PLANNING, ZONING, & BUILDING DEPARTMENT
PZ&B Staff Combination Memorandum: Architectural Commission and Town Council

SUBJECT: ZON-24-0045 (ARC-24-0082) 740 HI MOUNT ROAD (COMBO)

MEETING: OCTOBER 23, 2024, ARCOM
NOVEMBER 13, 2024, TC

New second floor window

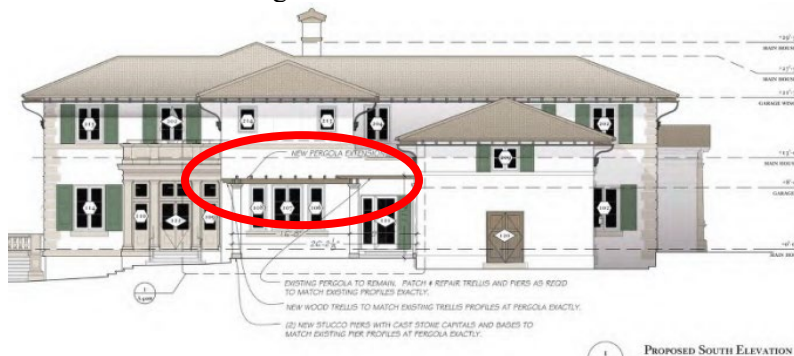
The subject property is located on the west side of Hi Mount Road along the intracoastal waterway just south of Country Club Road. The site features a well-designed Mediterranean Revival style single family home constructed in the late 1990's. The new owner would like to make minor modifications to the property. This includes the addition of a paired casement window on the second floor of the garage with lite pattern to match others and not visible from a public ROW. The second change is the addition/expansion of an open pergola consisting of cast stone piers with a base and capital supporting a cypress wood trellis on the west elevation to match the perpendicular pergola with the same architectural elements running north/south on the west elevation.

Red indicates proposed areas for demolition.

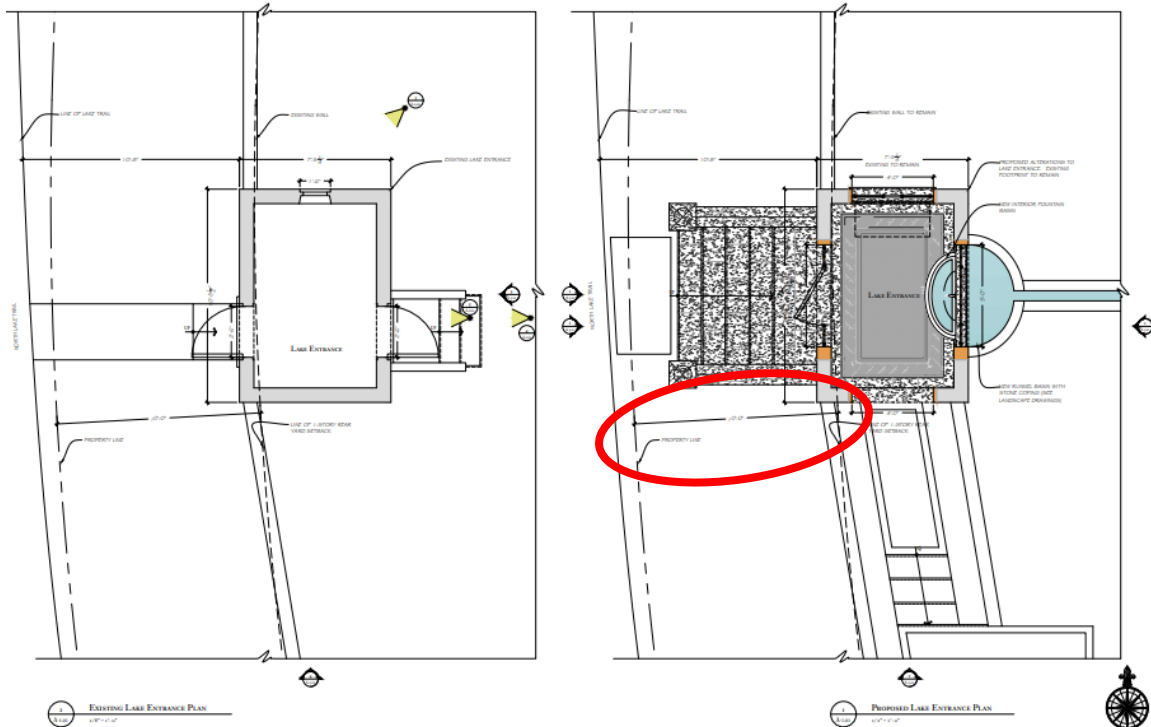
The final and most significant alteration is the reconstruction and reconfiguration of the existing entry pavilion along the west side of the property along the Lake Trail. Due to loss of over 50% of this element a variance is required to build back in the same footprint.

Proposed rear setback to match existing

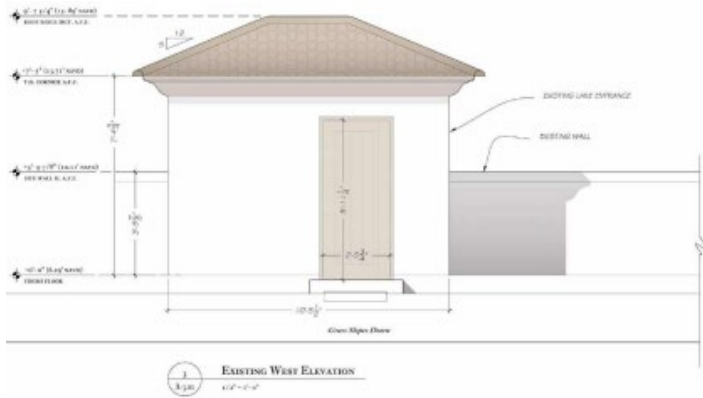
The applicant is proposing minor modifications to an existing primary structure and reconstruction of an entrance pavilion. A preliminary review of the project indicates that the application, as proposed, is inconsistent with the Town zoning code and requires one (1) variance to achieve the application due to the amount of proposed demolition on Lake Trail entrance pavilion.

Existing/Proposed west elevation as visible from Lake Trail ROW.

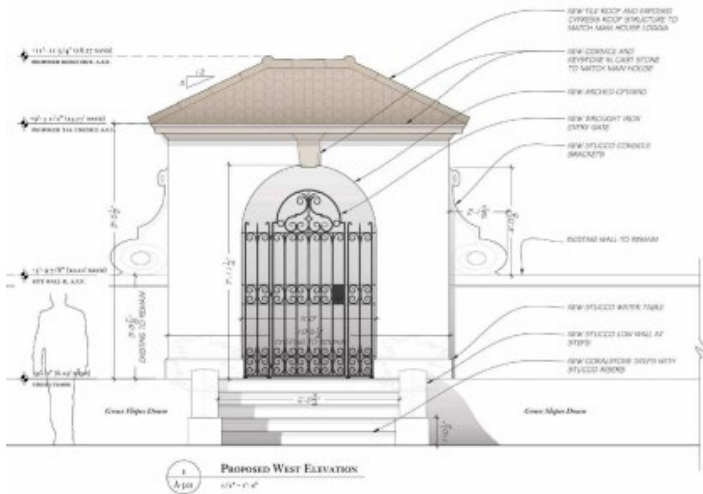
The west elevation is visible from the Lake Trail and now offers an enhanced design with a wrought iron entry gate. Passerbys will be able to get a glimpse through this entry feature to the fountain area versus the current utilitarian structure.
